Date	September 15, 2022
То	Town of Cumberland Planning Board
From	Carla Nixon, Town Planner
Subject	Planning Board Site Plan Review – Yarmouth Veterinary Center

The Applicant is Yarmouth Veterinary Center, LLC. The Applicant is requesting Planning Board Site Plan Review for the construction of a two-story, 14,662 sf. office building, associated parking, infrastructure, and landscaping on Lot #4 of the Heritage Village (formerly Cumberland Foreside Village) subdivision. There is an entrance from Route 1 that will be shared with Lot 3.

8. PEER REVIEW ENGINEER'S COMMENTS & RESPONSE FROM SME:

On behalf of Yarmouth Veterinary Center, LLC (YVC), Sevee & Maher Engineers, Inc. (SME) has prepared the following response to peer review comments by Gorrill Palmer in a memorandum dated September 8, 2022, and forwarded to SME via email on the same day.

TYPICAL UNDERDRAINED SOIL FILTER DETAIL NTS

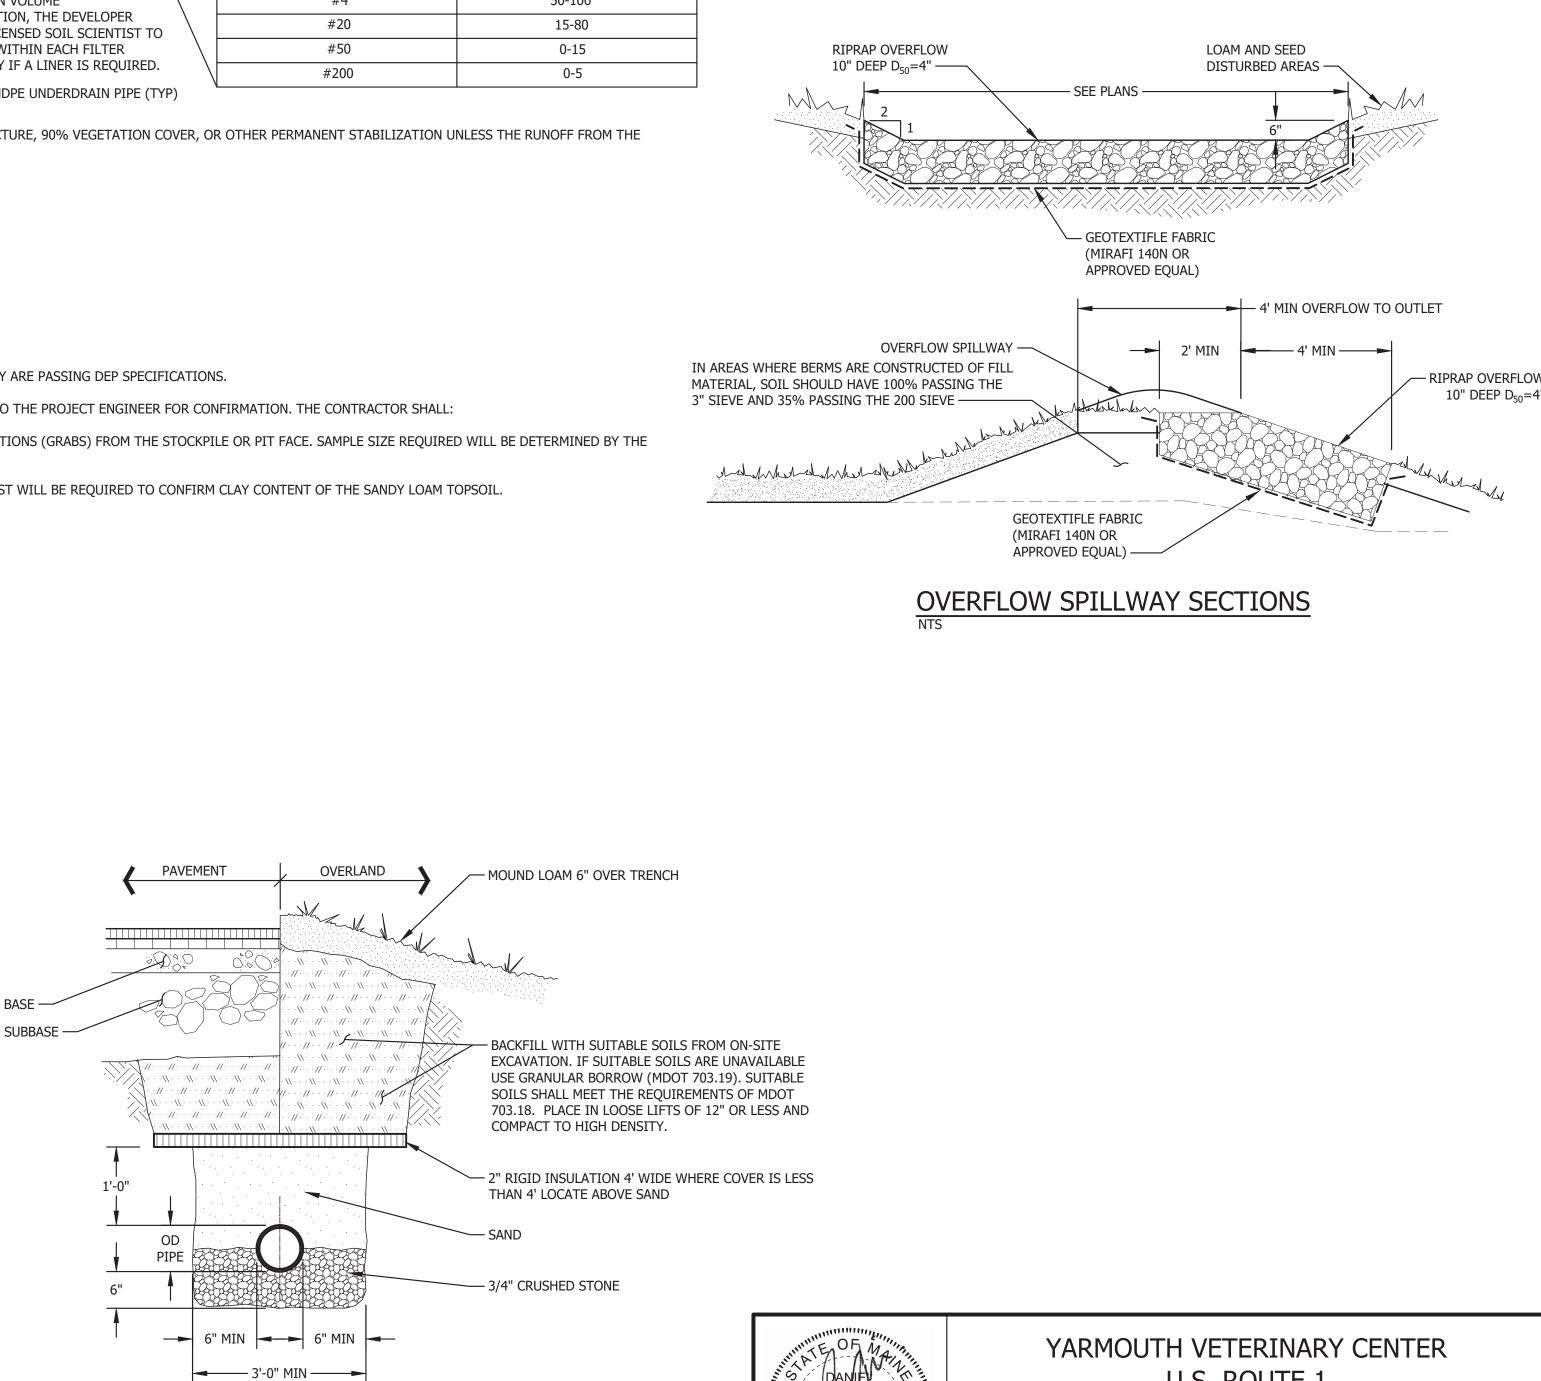
5. Site Grading Plan – The berm for the underdrain filter closest to the access drive appears to be 3' wide between the 102 contour, with a spot grade of 102.5 in the middle of the berm. We recommend that the Engineer reconsider the width of the berm as it appears to be less than desirable.

<u>SME Response</u>: We have had success permitting this detail with MEDEP on many other projects. The Underdrained Soil Filter detail on Dwg C-303 outlines an impermeable liner the full depth of the basin which makes an embankment failure highly unlikely. However, we will consider this change and update the plan set to include a wider berm with the next plan revision, if necessary.
